Viking CCS Pipeline

9.6 Design Changes 1 and 2: Environmental Technical Note

Document Reference: EN070008/EXAM/9.6

FIGURE TITLE
Figure 1
Design Change 1 - Amendment to Order Limits at the Immingham Facility

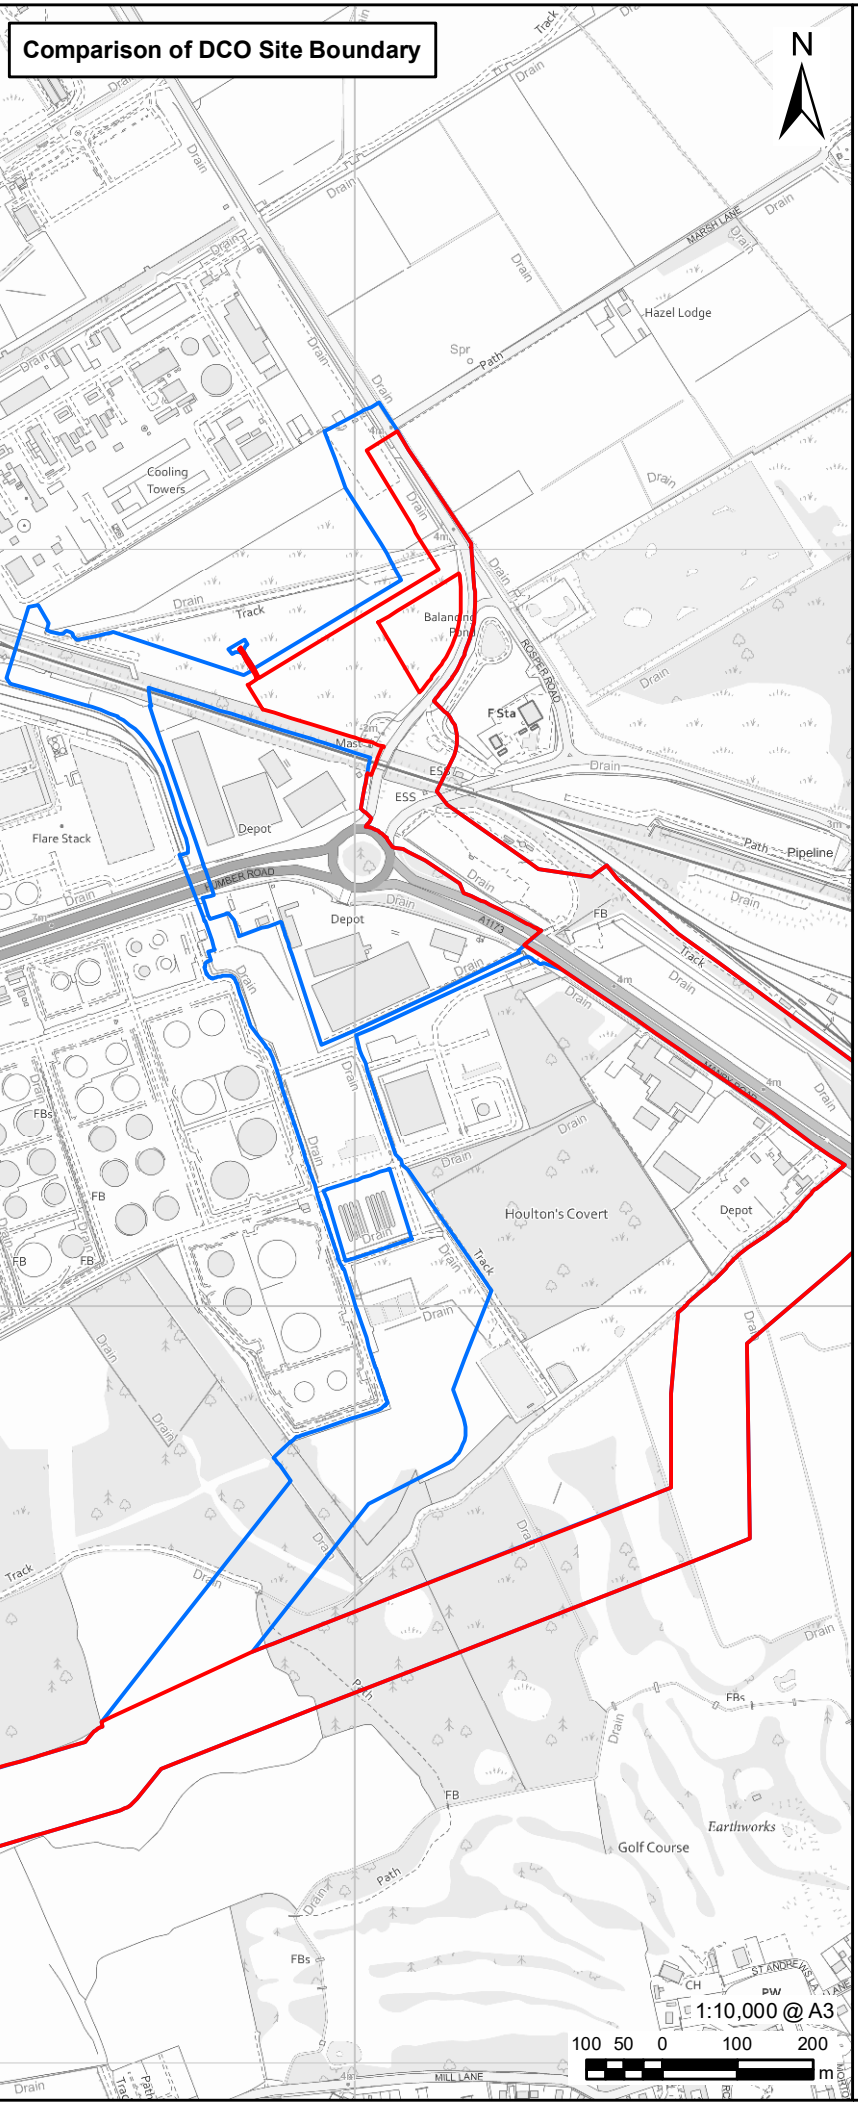
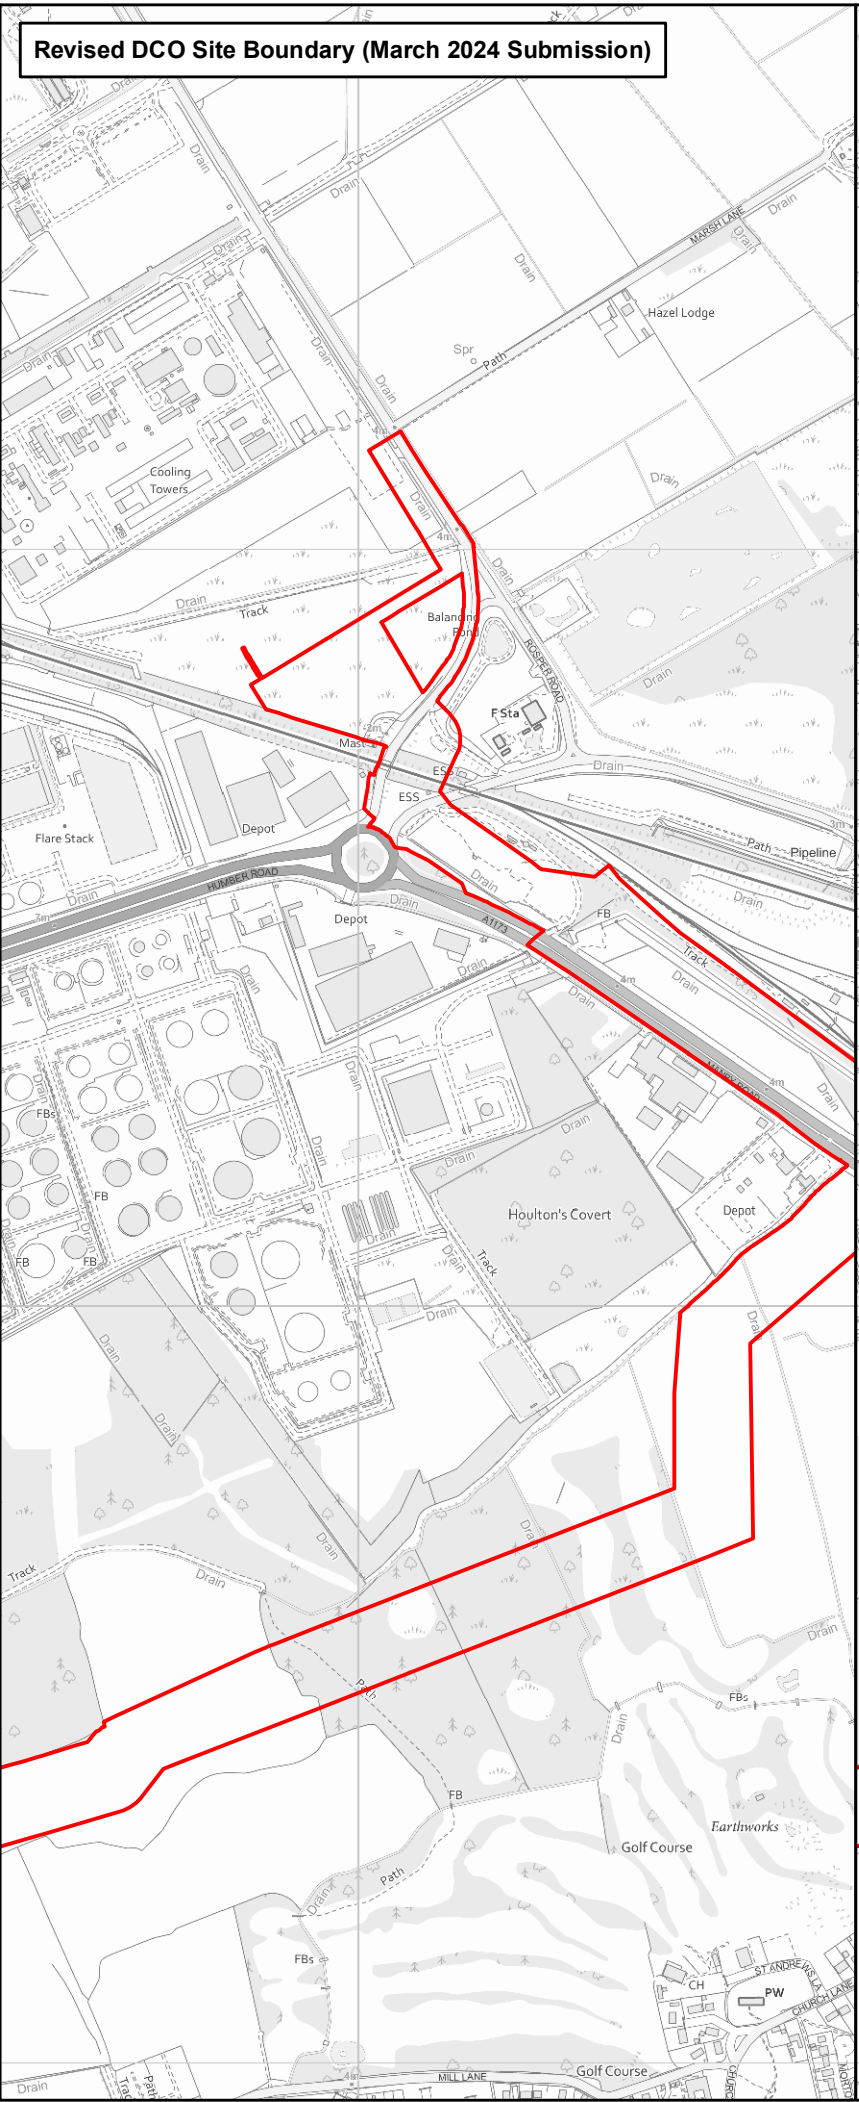
2.2.2 The change involves a reduction in the Order Limits, as a result of further defining the access routes and fixing more closely the anticipated location of the Immingham Facility itself. This change has been informed by further engagement with interested parties.

2.2.3 This change would result in reductions to the Order Limits as shown in **Figure 1**. No additional land outside of the current Order Limits is required. The reduction in the area of the Order Limits for Design Change 1 totals 2.55 hectares.

FIGURE TITLE
Figure 2
Design Change 2 - Removal of pipeline option 2 exit route from the Immingham Facility

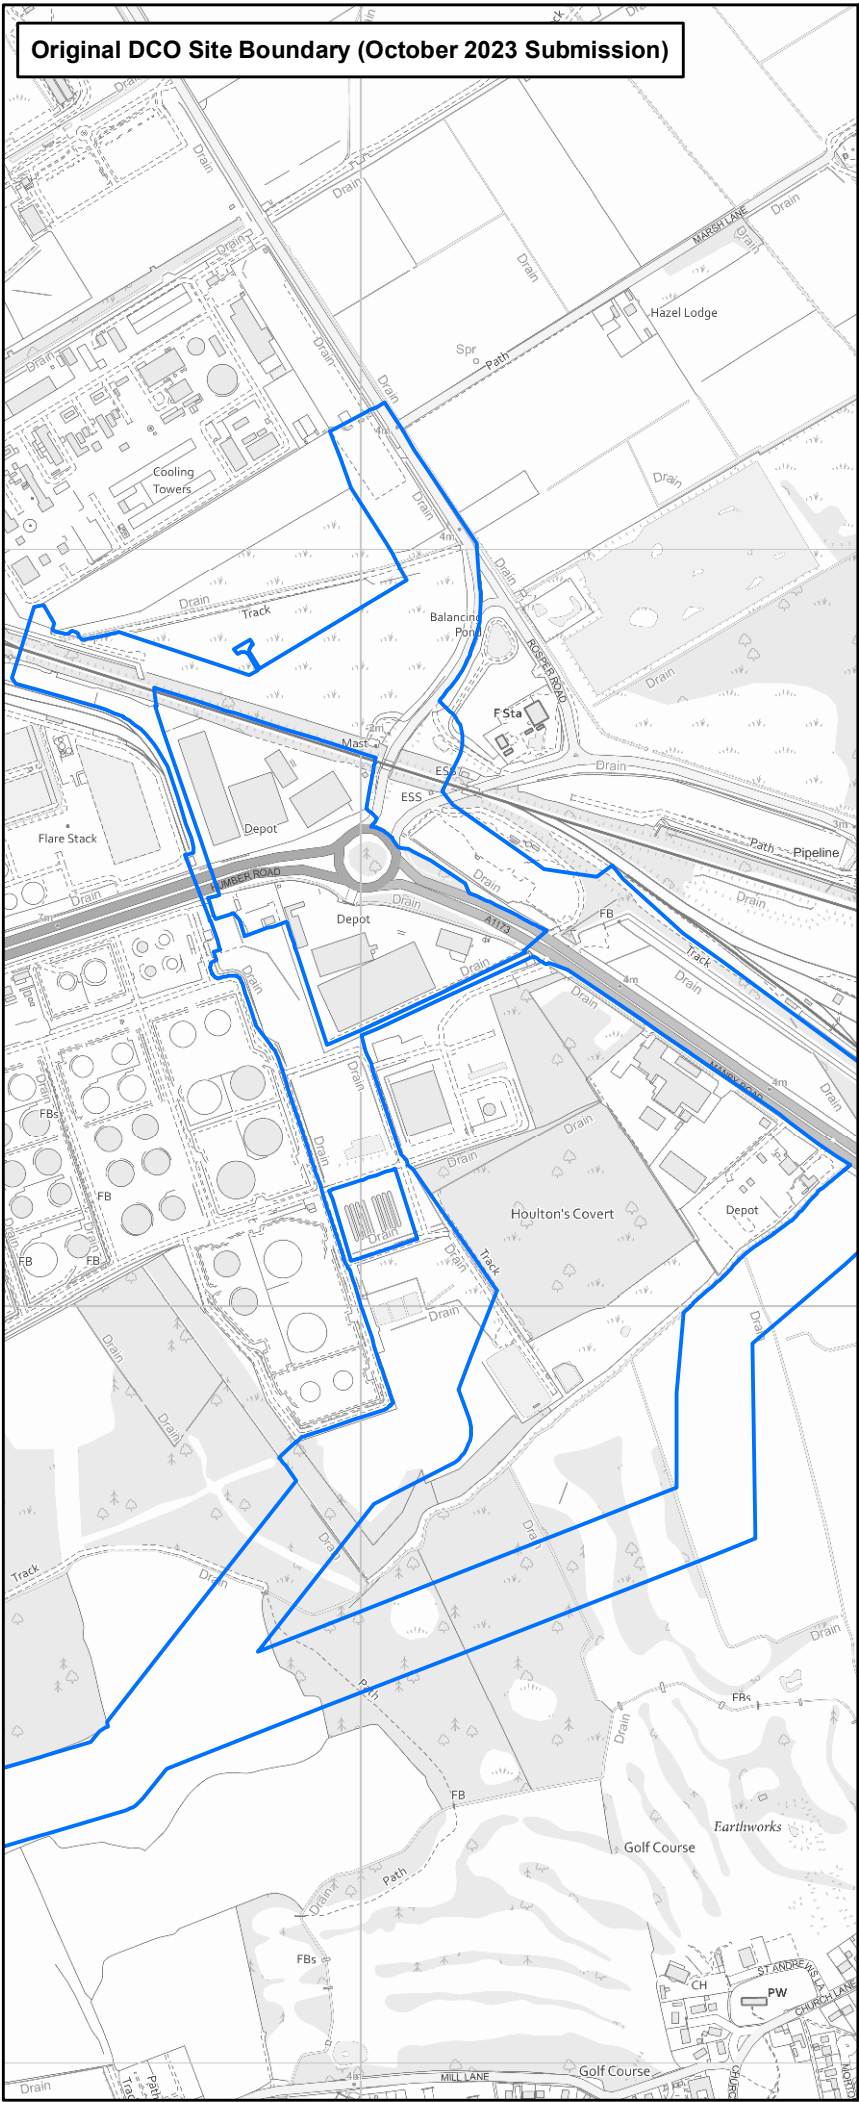
2.3.2 As a result of further discussions between the Applicant and P66, it has been concluded that Option 2 is no longer a viable option and thus will be removed from the application.

2.3.3 This change therefore involves a reduction in the Order Limits and would thus reduce the area of land included in the Order Limits, as shown in **Figure 2**. The reduction in the area of the Order Limits for Design Change 2 totals 16.06 hectares. This change would also remove two temporary access and laydown areas which would no longer be needed. Consequently, this change also means that it is confirmed that the pipeline will exit the Immingham Facility using Option 1.
